Subject: **Bid No. 8568-J6 – Water Tank Cleaning and Repairs / DPW**

ADDENDUM NO. 1

CIVIL WATER STORAGE TANK DETAILS I			
CITY OF WORCESTER, MASSACHUSETTS WATER STORAGE TANKS REHABILITATION	Drawn By: T&H Designed By: SHD Checked By: AMG	Approved By: SHD	Approved By: AMG

MILLSTONE CONCRETE DOME PLAN

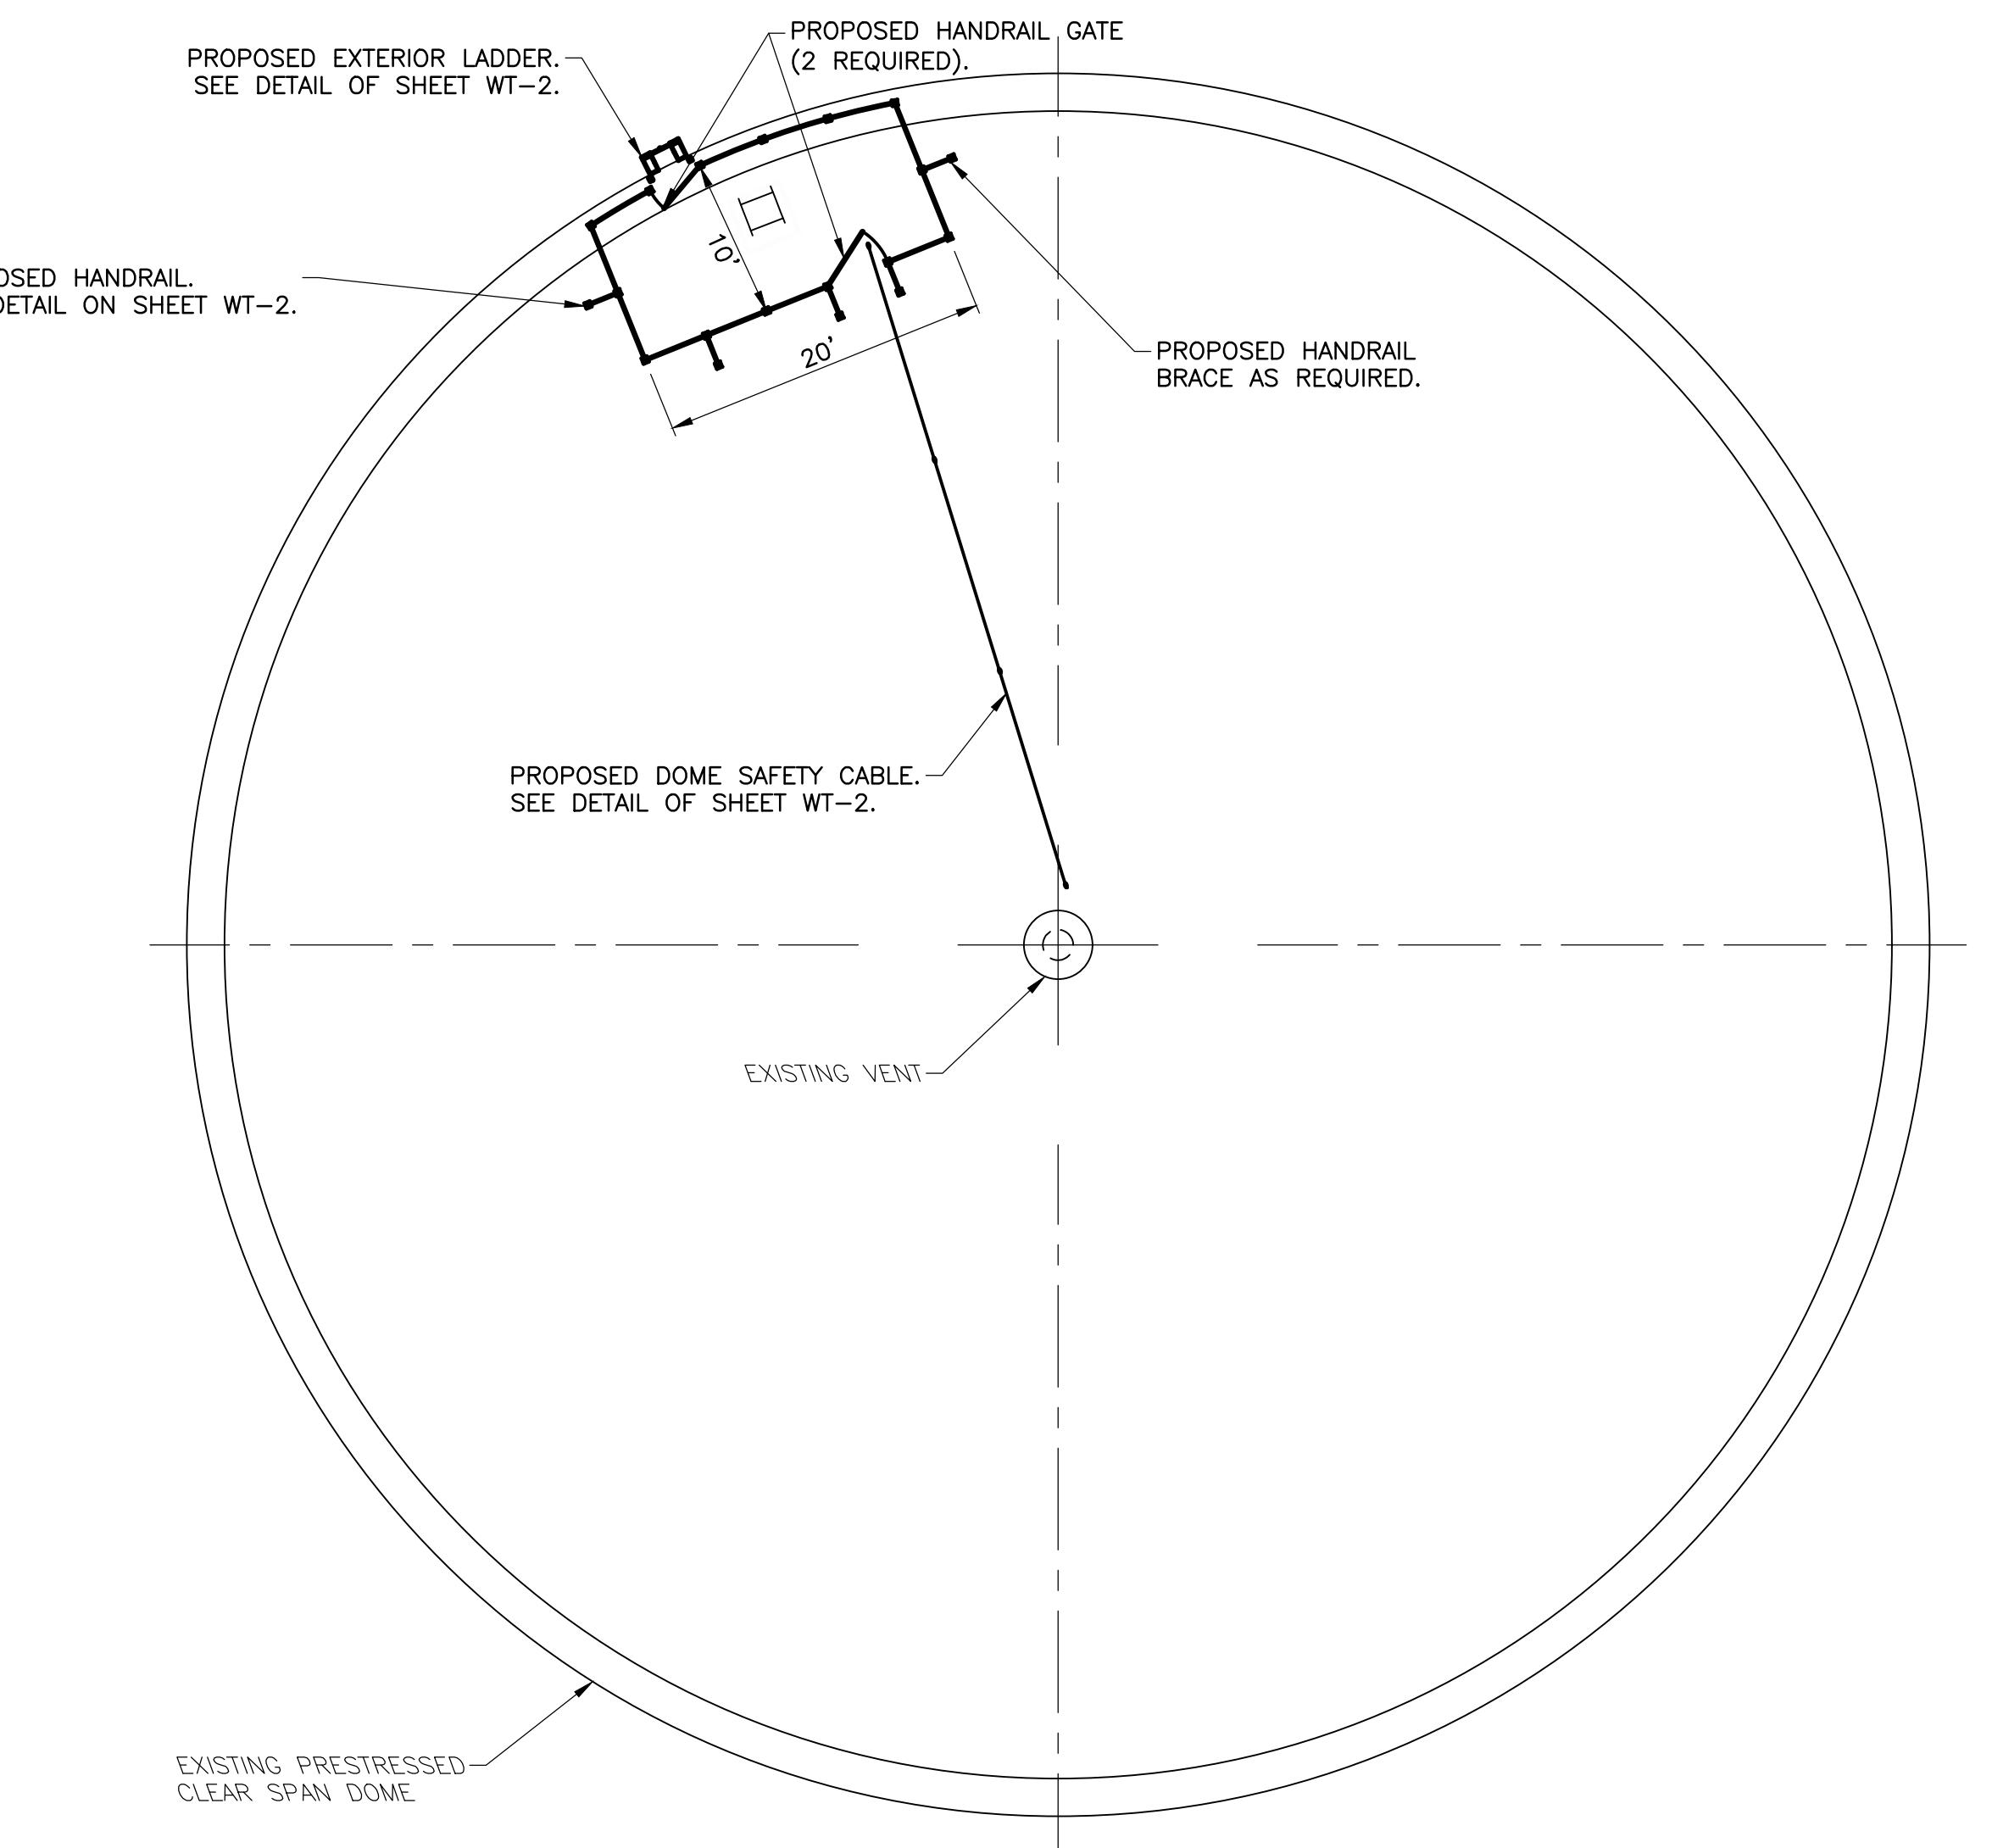
Q5. What are the dimensions for the handrail corral?
A5. See attached drawing for handrail corral dimensions at the concrete water storage tanks.
